SERVICE BULLETIN

Subject: Motor Overload Relay

Bulletin No. SB09-5

Figure 1

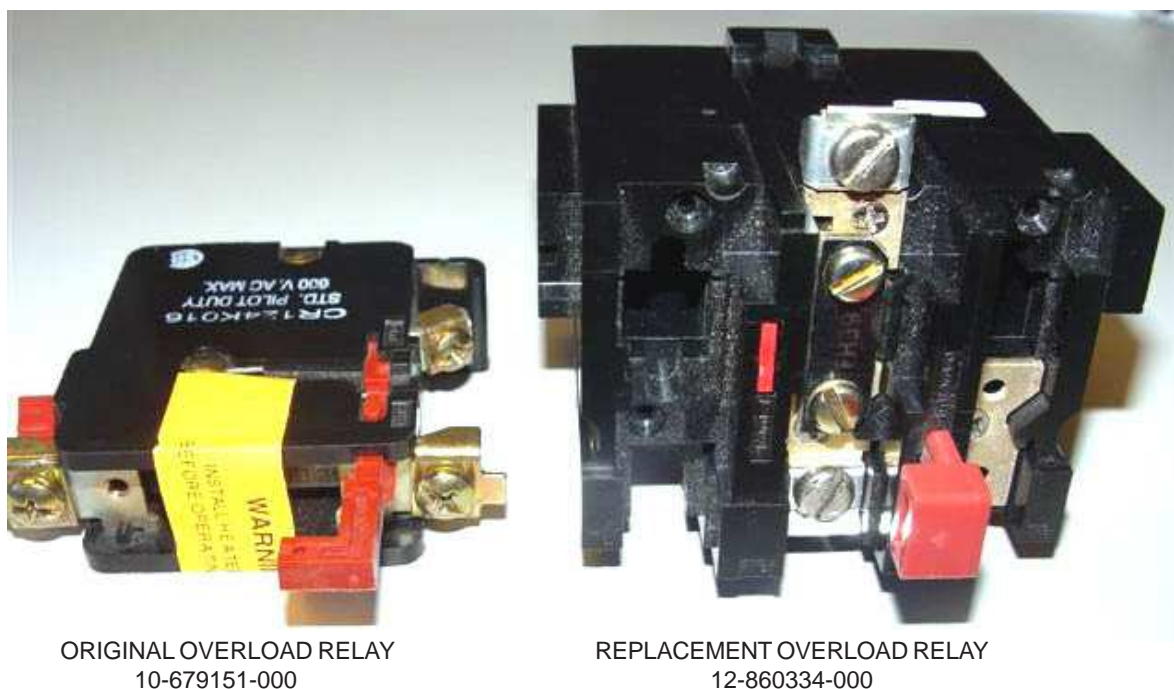
This Bulletin is to inform A and A-2 pinsetter customers that the Motor Overload Relay, part number 10-679151-000, is no longer available. Critical components to the original relay can no longer be manufactured by the supplier. This relay is used to protect the pinsetter motor and electronics when the motor starts to draw excessive amps during operation.

To continue supporting Pinsetters that utilize this relay, a replacement has been designed. The replacement overload relay performs the same as the original, but is larger with different dimensions, and requires modification to the electrical box to operate safely. Instructions will be provided when a replacement relay is ordered to make this modification. The part number of the replacement Motor Overload Relay is 12-860334-000. Refer to *Figure 1*.

If the Motor Overload Relay, part number 12-860334-000, is required, the relay must be installed with a heating element. To determine the appropriate heating element, check the Full Load Amps on the motor identification plate. Noted below are the heater part numbers for the redesigned Motor Overload Relay:

i *Note: Old heaters are not compatible with the new Motor Overload Relay.*
